June 24, 2014
Medway Planning and Economic Development Board
155 Village Street
Medway, MA 02053

Thayer Homestead As-Built Plan:

Learning Tree Site Plan – Public Hearing

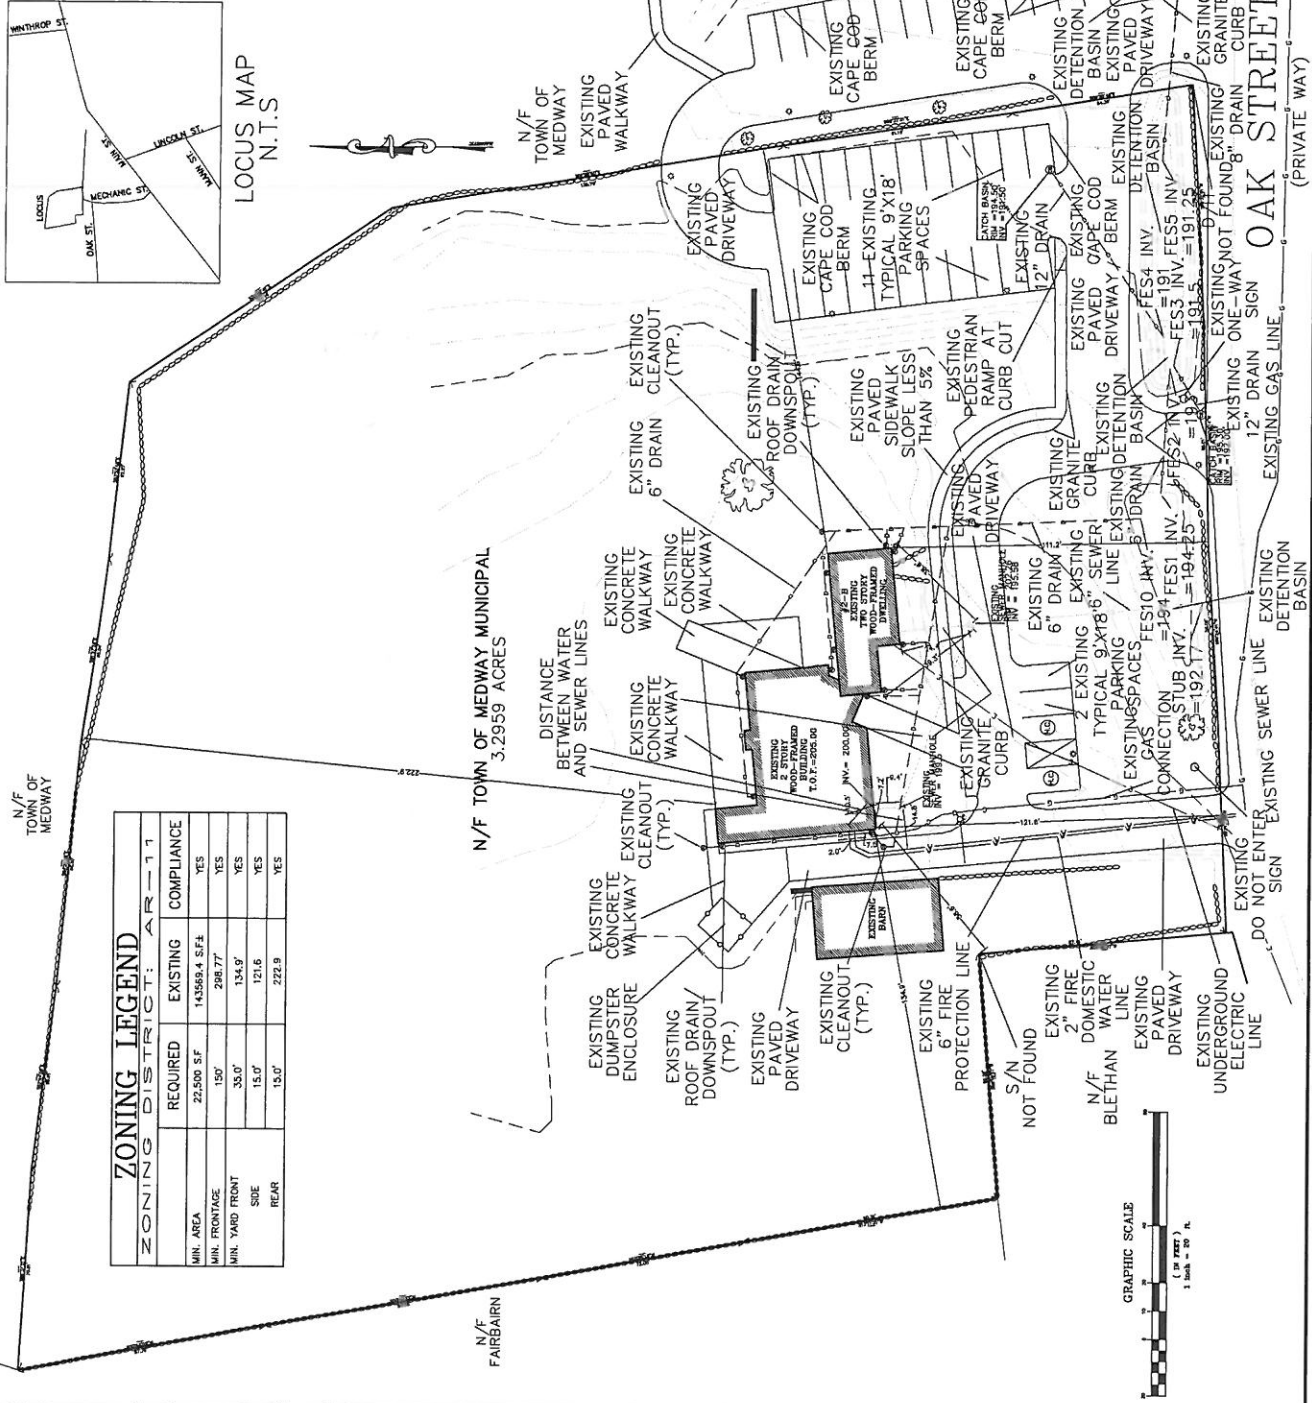
Consultant Marchetti informed the Board that the as-built plans submitted for the Thayer Homestead need to be fixed since the text on the plan is too big. The Board does not want to vote on the Thayer Homestead until all the changes have been fixed.

This plan is still not looking good. The text is still very large and congested and it doesn't look like they did anything from the previous submission. After speaking with the surveyor who worked on the plan I was under the impression that the text would be the correct size, much like the text as shown in the legend on the plan and as noted in our letter. The text shown on the plan is technically per the regulations since it is at a minimum of 1/8" but it does not look presentable at all. They also did not respond to our previous letter. Let me know how you would like to move forward with this because I know you wanted to have a determination today.

SHEET:
SITE PLAN
CFG 4.0

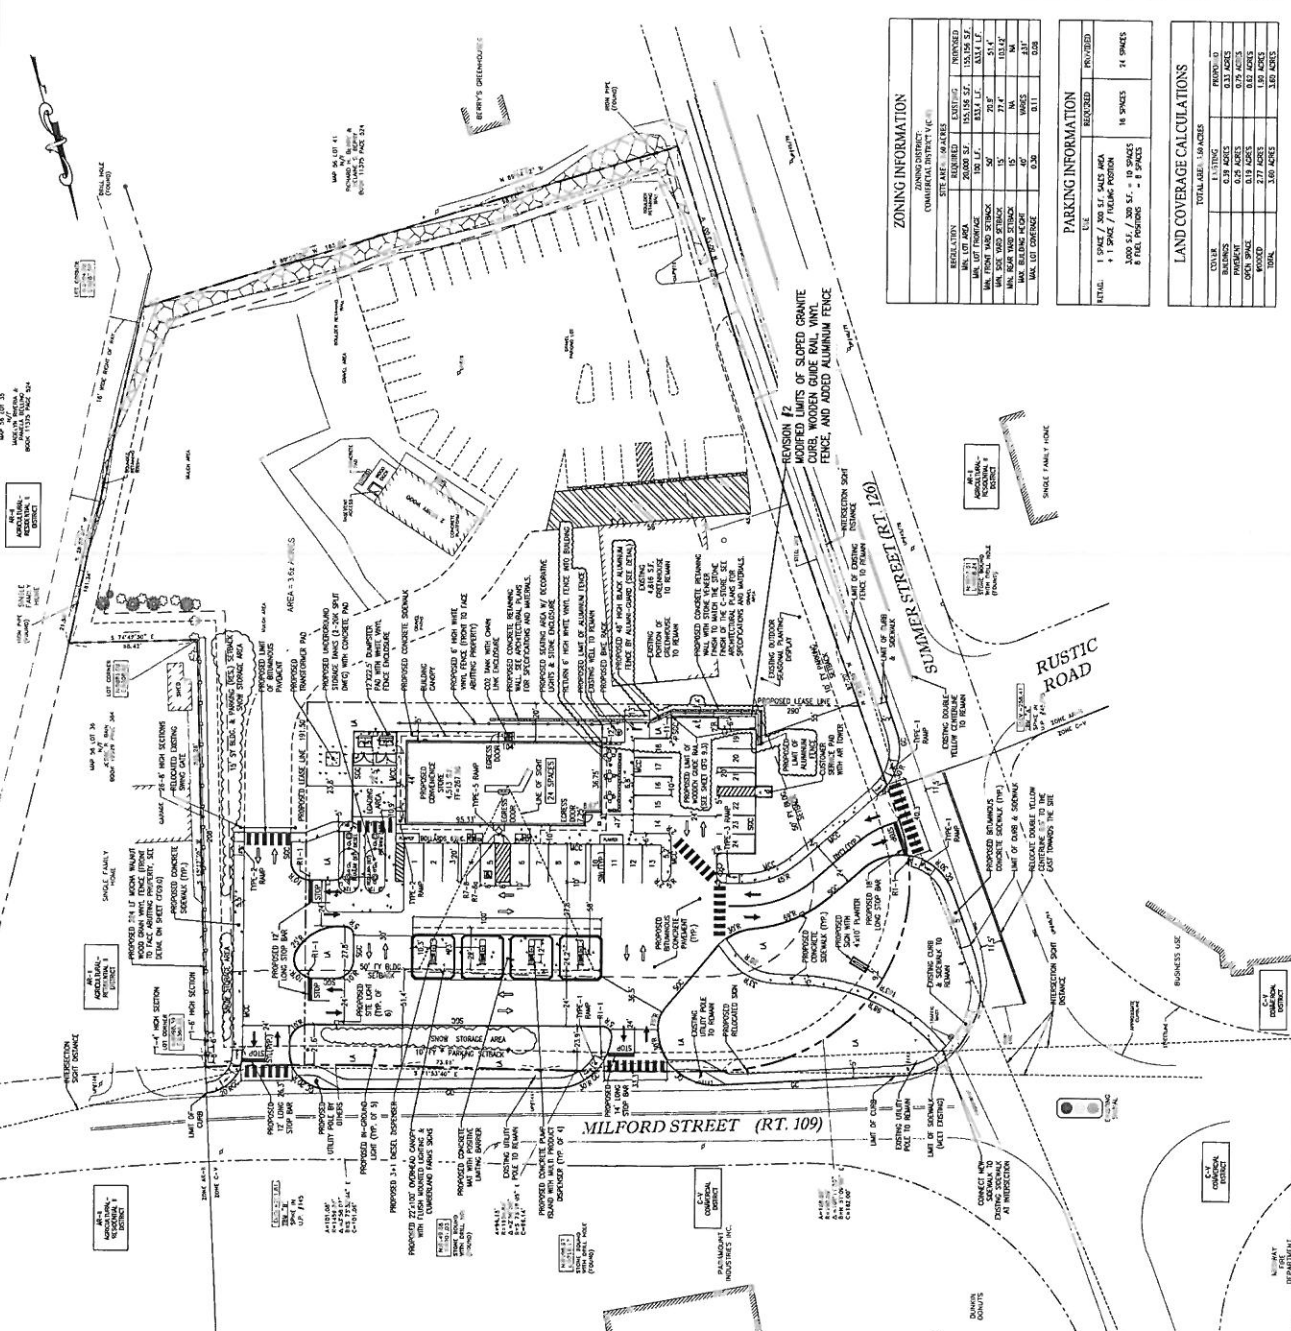
The Board is in receipt of a requested construction change from engineer Phil Henry dated 6/18/2014. (See Attached.) The proposed change showed a photo of the proposed fence design. The recommended fence is for pedestrian safety purposes. The drainage will be started next week. Member Spiller-Walsh did a site visit to identify the rocks which will be saved. The consultant noted that the purpose of the fence is for aesthetic reasons.

Per our phone conversation, I am attaching a revised site plan that proposes a minor change to provide additional edge control along the portion of retaining wall with the stone veneer finish. As approved, there was wooden guiderail extending from the bike rack to the westerly edge of the retaining wall proximate to parking space 19. In speaking with the Contractor, we would like to introduce a 48" high ornamental aluminum fence in addition to the guiderail for additional pedestrian safety. The attached site plan depicts the limit of the aluminum fence and the attached detail sheet provides a cross section for installation purposes, all of which are rev-clouded for your convenience. I am also including a photograph from a recently constructed Cumberland Farms that includes the specified fence. As we discussed, we consider this a minor change but wanted to forward to your attention. Please advise if there any concerns on the Town's behalf.

On a motion made by Karyl Spiller-Walsh and seconded by Bob Tucker, the Board voted unanimously to accept the construction change order from Cumberland Farms as presented.

**SITE PLAN
 OF LAND IN
 MEDWAY, MASS.**

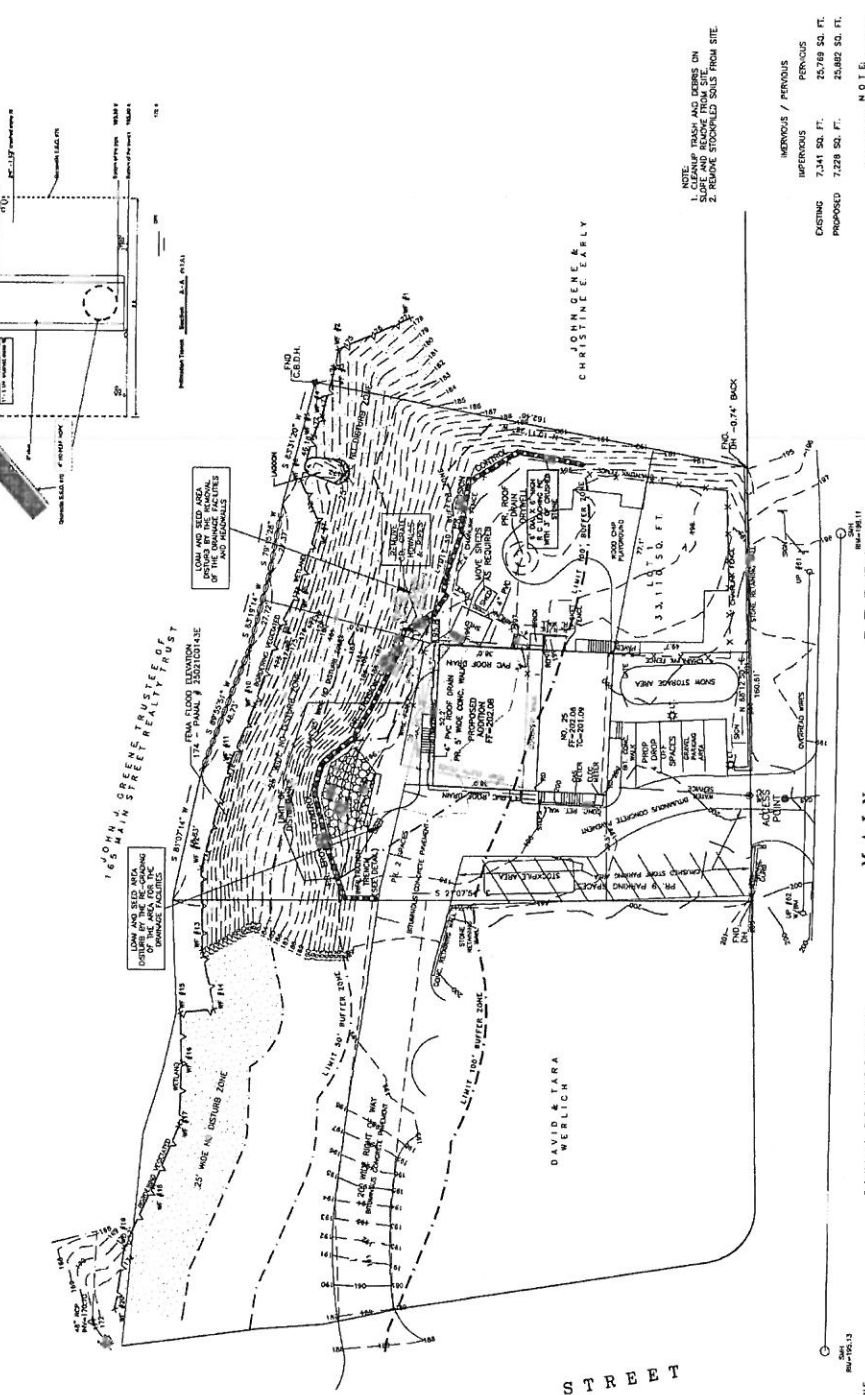
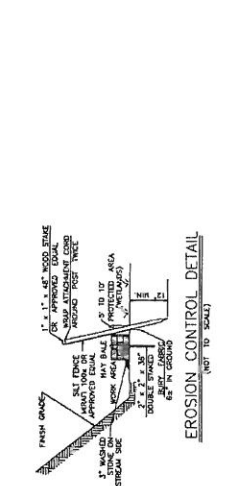
Consultant Marchetti suggested that this area is adequate for one way access and the parking is adequate. The applicant should provide an existing conditions plan to show the location of the man-made features such as gas, poles, utilities, fire hydrants etc. The Consultant wanted to make sure the ADA stalls are noted on the plans.

3. Section V. P. 1. (c)(1) does specify parking standards for exempt uses including child care facilities. It requires 1 space for every paid and unpaid employee. It is unclear how many employees there will be at the expanded facility when it is operational. It also requires dimensions of 9' x 18.' No dimensions are shown on the plan.

LANDSCAPING
PLAN
EXISTING
PROPOSED

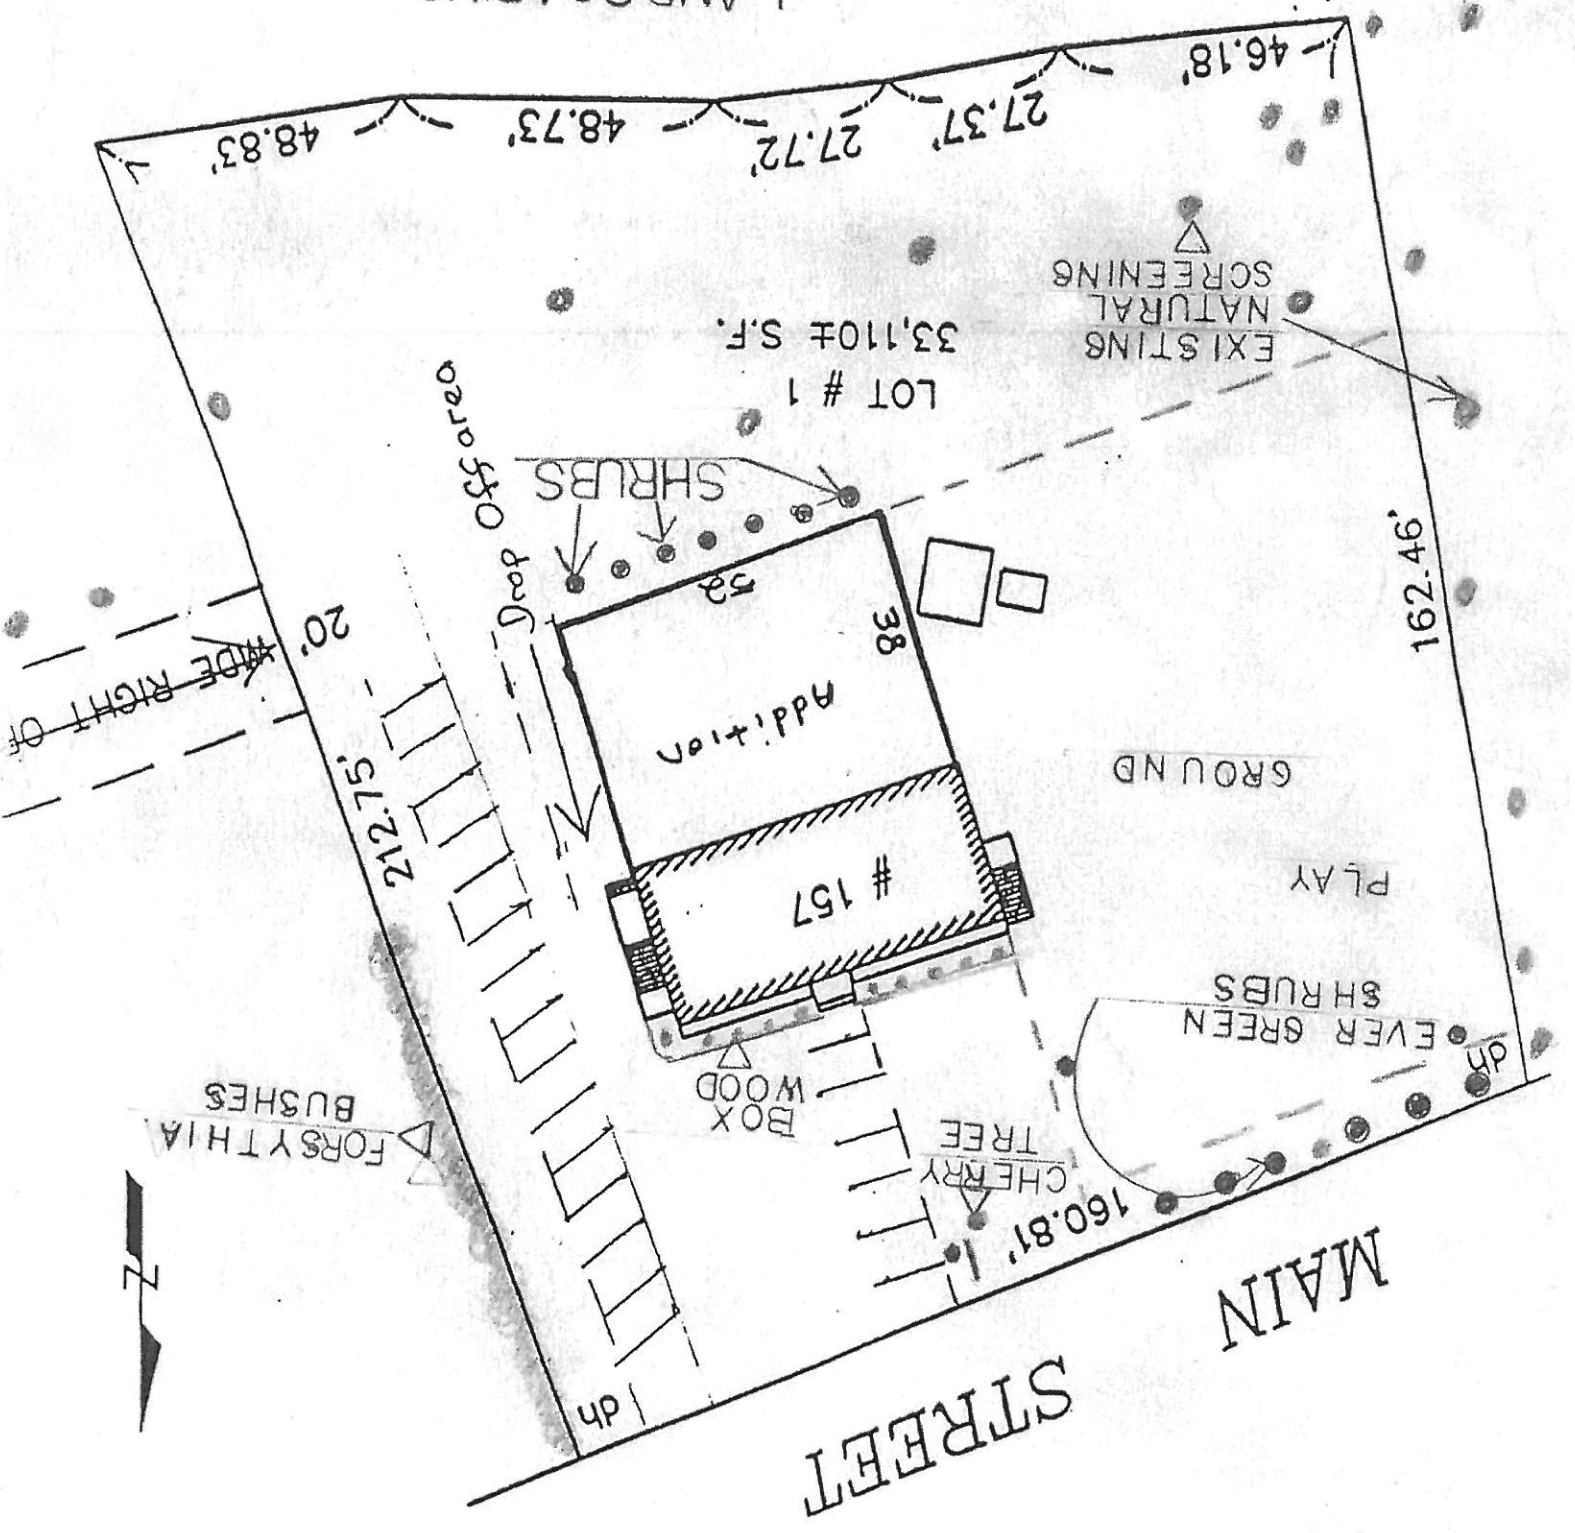
13. Section 204-5 D. (7) requires that a landscape plan be prepared by a landscape architect. There is no indication that a landscape architect prepared the landscape plan and no waiver is requested. The landscape plan is not specific regarding the proposed species or specifications (caliper and/or height) of the plantings proposed.

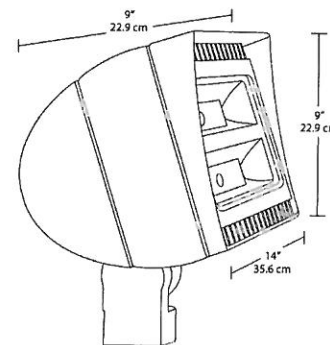
Consultant Carlucci questions whether the easement and its rights include the permission to park within the driveway. The bylaw states it is one space per 300 square feet. The existing parking is gravel or crushed stone. There are two spaces on the east of the property and one appears to be on the abutter's property. There would need to be clarity in relation to the "right-of way" and permission to park there. The applicant would meet the criteria by specifying a time drop off. He also informed the applicant that the lighting plan exceeded .01 for candles. This will need to be changed.

8. Section V. B. 7. (e) (1) states that light trespass onto any abutting street or lot is not permitted. The applicant states that no increase in ambient light will occur. A photometric plan was provided and it indicates that the foot-candle level at the property lines exceed .01 in most places around the perimeter.
